Subject: AP1000 Response to Request for Additional Information (SRP 6)

# AP1000 TECHNICAL REPORT REVIEW

RAI Response Number: RAI-SRP3.7.1-SEB1-16  
Revision: 2

**Figure RAI-SRP3.7.1-SEB1-16-1: AP1000 Auxiliary & Shield Building Main Control Room - Hard Rock High Frequency Safe Shutdown Earthquake Floor Response Spectra Horizontal Direction, At Elevation 116.5'**

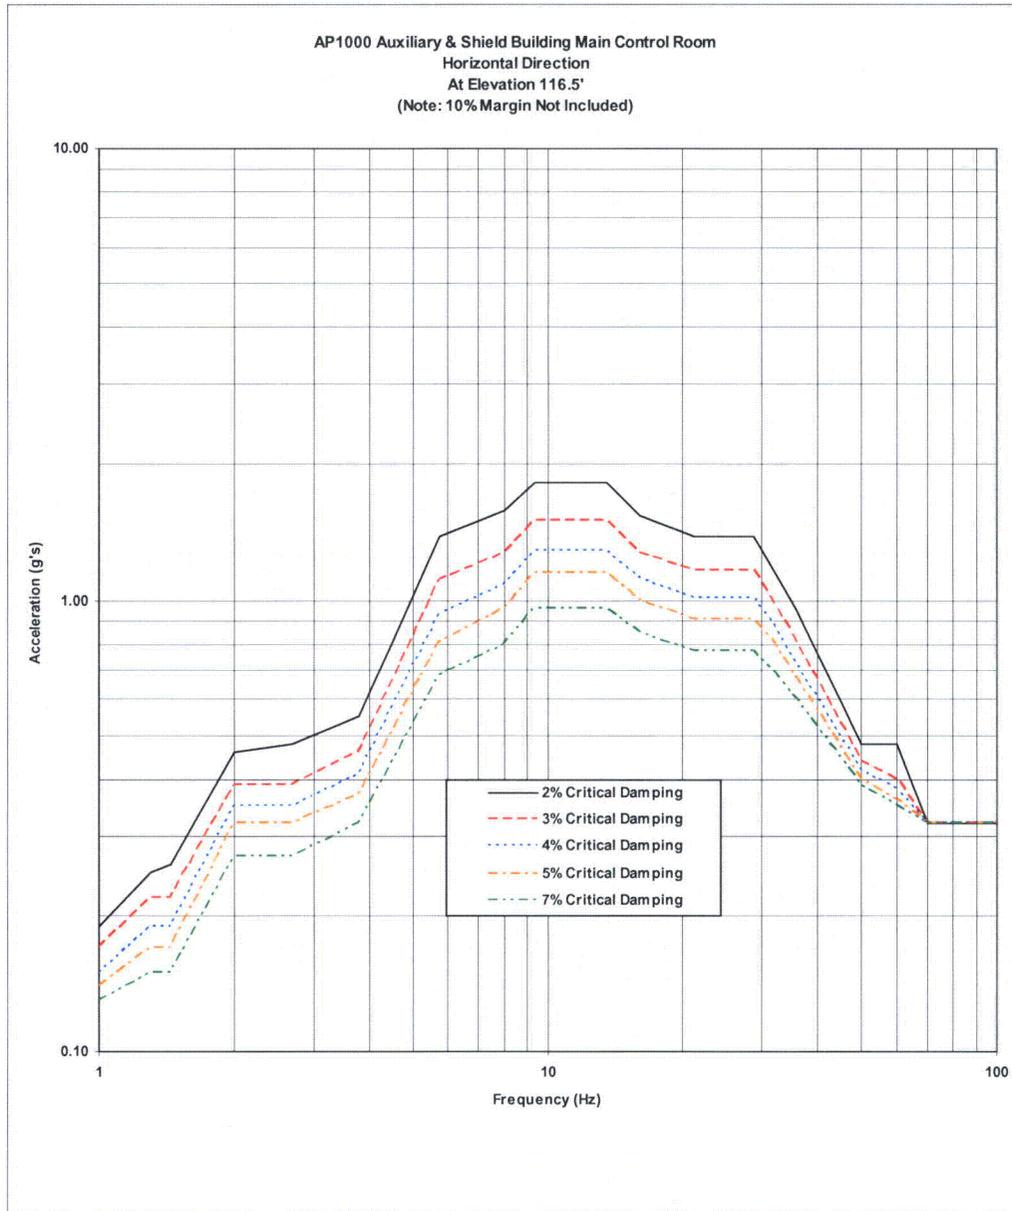
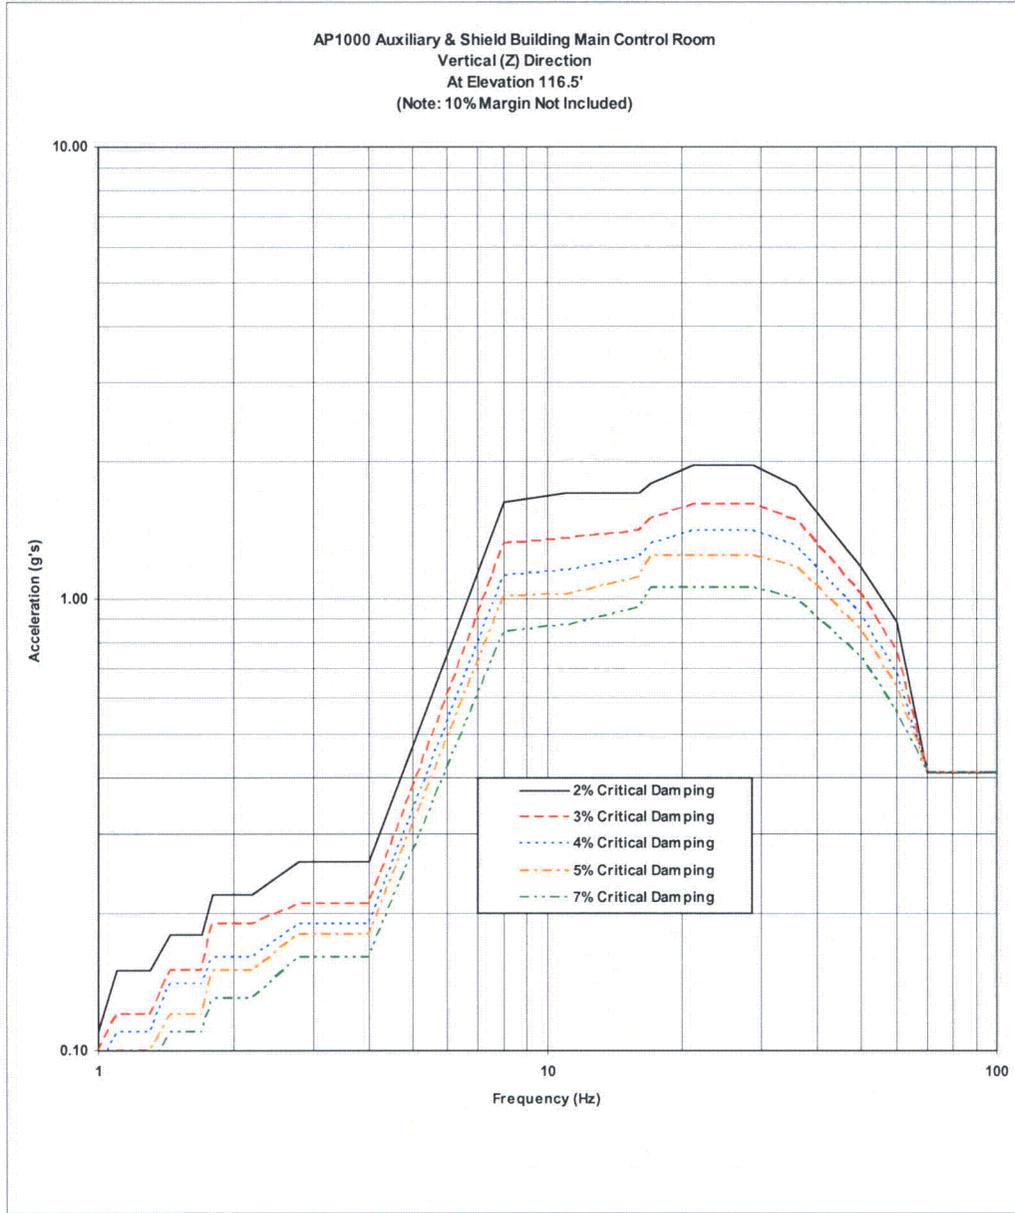
02/25/09 UPDATE: Response submitted 02/06/2009. The responses to (a), (b), (c), and (d) are unacceptable. For (a), only the structural loads are addressed. The more important

consideration is the effect on the HRHF in-structure response spectra needed for analysis of systems and components potentially susceptible to high frequency excitation. For (b), W needs to define a technical basis for demonstrating similarity. Otherwise, it is subject to interpretation by each COL applicant. For (c), the impact of complying with RG 1.61 Rev.1 for electrical cabinets is negligible, since seismic qualification analyses have not been performed yet. If seismic qualification is by test, the specified damping for analysis has no importance. For (d), W needs to justify using 5% damping for piping analyses using HRHF in-structure response spectra. This is a violation of the Rev. 15 FSER. Complying with RG 1.61 Rev.1 damping for piping analyses would require minimal re-work, if any. The design-basis piping seismic analyses for most, if not all, systems that will utilize uniform support motion RSA methodology and 5% damping, have not been performed yet.

To address the potential that the seismic response for the HRHF SSE ISRS may have been underestimated, additional seismic test margin will be introduced into the HRHF seismic screening evaluation of safety-related equipment vulnerable to HRHF excitation. U.S. NRC R.G. 1.61, Rev. 0 identifies a critical damping value of 4% for ½ SSE analysis of reinforced concrete structures. The margin between 4% critical damping and the 7% critical damping used for the building structural analysis is approximately 30%. This margin will be realized in seismic testing by using the 3% damping HRHF SSE ISRS as though it were a 5% damping HRHF SSE ISRS. Figures RAI-SRP3.7.1-SEB1-16-1 and RAI-SRP3.7.1-SEB1-16-2 provide a comparison of the 3% and 5% HRHF SSE ISRS for the Main Control Room (horizontal and vertical direction) which shows a margin of approximately 30% for frequencies below the ZPA.
